**Waterford Unit 3 GSI-191 Generic Letter 2004-02  
Corrective Actions Audit Report**

ENCLOSURE

**Figure 1: Waterford 3 Containment Pool Flow Velocity for Break S7**

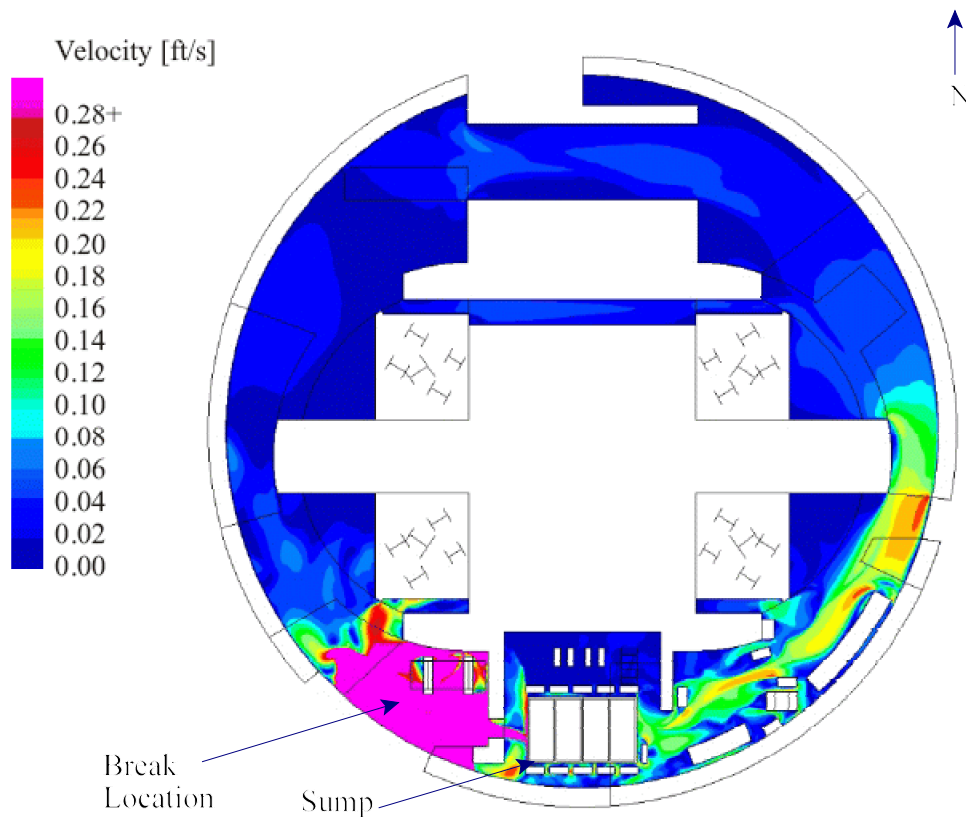
The first concern is that the staff concluded that there is inadequate technical basis for the licensee to assume that the percentage of debris transporting along the east and west sides of containment is equal to the percentage of flow approaching the sump from the east and west side of containment. Although there are limited conditions under which the licensee's assumption may be reasonable, the staff expects that the location of the break would generally have a significant impact on which side of containment debris will transport, regardless of the flow split between the east and west sides of containment. The staff's expectation is borne out by most of the plots of pathlines from the breaks to the containment sump that are included in the debris transport calculation for the CFD simulations performed by the licensee [16]. These plots suggest that debris transport would be generally biased toward the side of containment on which the break occurred and, in many cases, overwhelmingly so. Furthermore, as noted in the

debris transport calculation, the flow in the Waterford Unit 3 containment pool was found to be highly three-dimensional [16]. This observation further suggests that the use of the total flow to the sump from the east and west sides of containment (i.e., a summation over the vertical flow distribution across the entire 5.05-foot depth of the containment pool) may not be a reasonable predictor of the direction of travel for pieces of Nukon and RMI debris transporting predominately only several inches above the containment floor. The lack of technical validity of the licensee's assumption is significant because the use of the assumption could result in non-conservatively low debris transport fractions under some conditions if sufficient countervailing conservatisms are not incorporated into the analysis.

The second concern is that the licensee's debris transport calculation did not clearly define the point at which the transport paths from the east and west sides of containment to the sump strainers were assumed to begin. Although the results of the licensee's transport calculation were consistent with the interpretation that the transport path on the side of containment with the pipe rupture begins at the point where this break water enters the containment pool, the licensee could not explain where the transport path on the opposite side of containment was assumed to begin.

For a related case in point, consider Figure 1 above. Clearly, as the licensee determined, the transport metric for Nukon LDFG for the S7 Break (0.06 ft/s) is exceeded on the west side of containment. However, the licensee further determined that no transport from the east side of containment would occur for this break. While it is clear that the flow velocities in the clockwise direction from the break to the sump in the annulus around the steam generator compartments is too low to transport all but suspended debris, there is a flow stream in the southeast quadrant that appears to be significantly in excess of both the assumed tumbling transport metric of 0.06 ft/s for near-sump Break S7, as well as the assumed transport metric of 0.12 ft/s for breaks far from the sump (see Table 5 above). Analogous observations were made concerning the other breaks analyzed by the licensee. As a result of these observations, the staff questioned the licensee's basis for assuming that no debris would be transported to the sump via flow streams such as those identified in Figure 1 above. In particular, the staff noted that debris could be situated in relatively high velocity flow streams on the side of containment opposite the break due to transport occurring during the blowdown, washdown, and pool-fill-up phases of the LOCA. The licensee did not provide a sufficient basis during the audit to resolve the staff's questions in this area.

**Figure 2 - Sector Head Loss Test Loop**

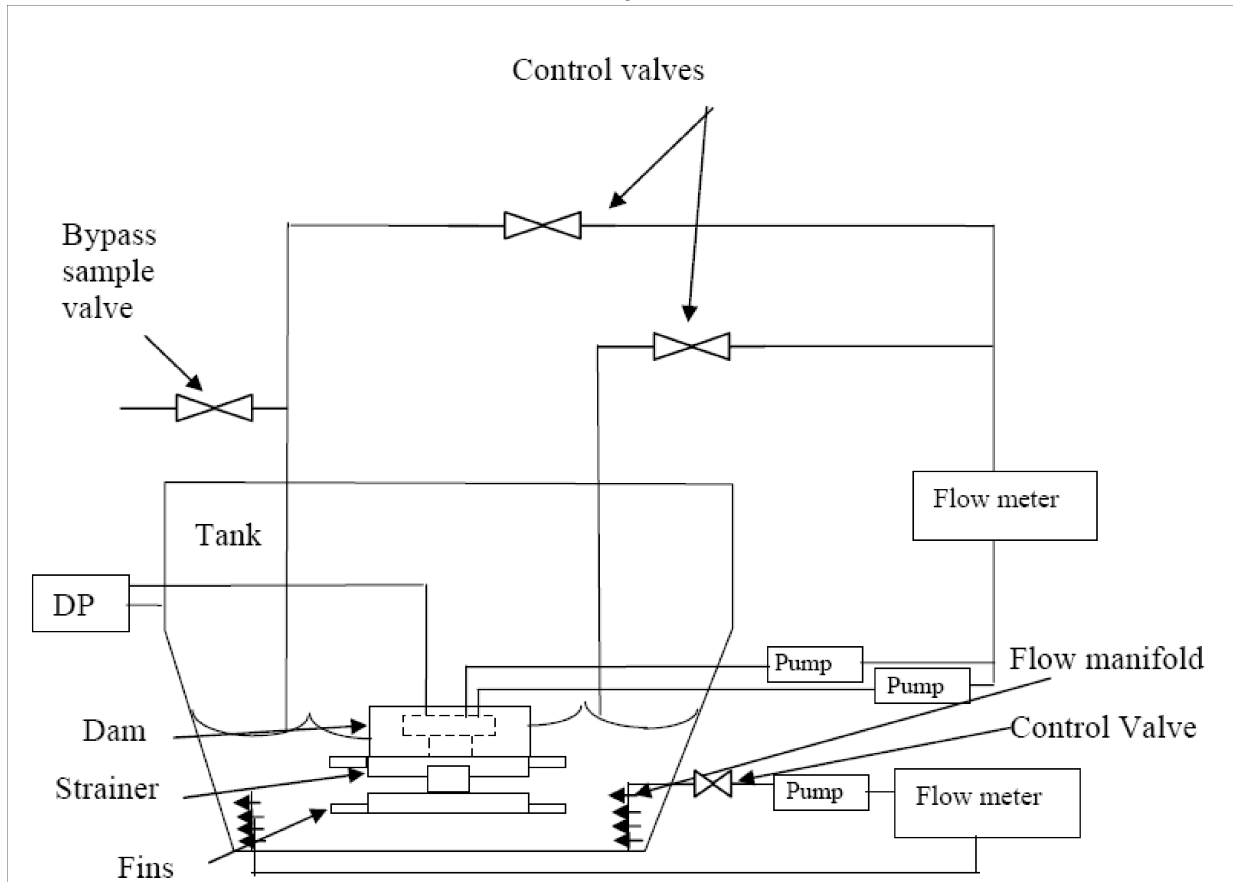
The addition of the fibrous debris in a mass close to the test strainer results in two non-prototypical effects as described above. The need for the licensee to provide the results of assessment of the potential for non-prototypical settling and non-prototypical bed formation due to debris agglomeration during partially stirred strainer testing is designated as **Open Item 10**.
